Access Compliance Report

Public Rights-of-Way

Intersection ID: 11958	Main Street: E_16TH_ST	Cross Street: SEIGLE_AV	Location: W
ADA ID: 8F3F7E890F1D	Ramp Type: Perpendicular	Initial Pass/Fail: Pass	Overall Compliance: No
		Severity Score: 2.5

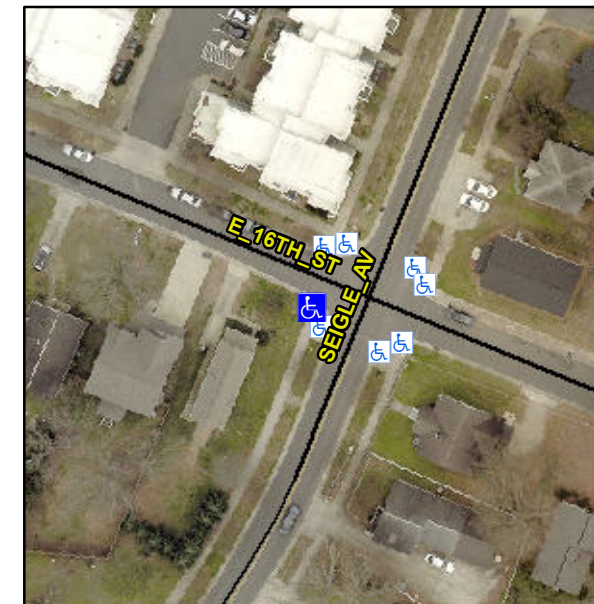
Remove & Replace Detectable Warning System. Remove & Replace Gutter.

R305.1.4, R305.2, R304.5.3
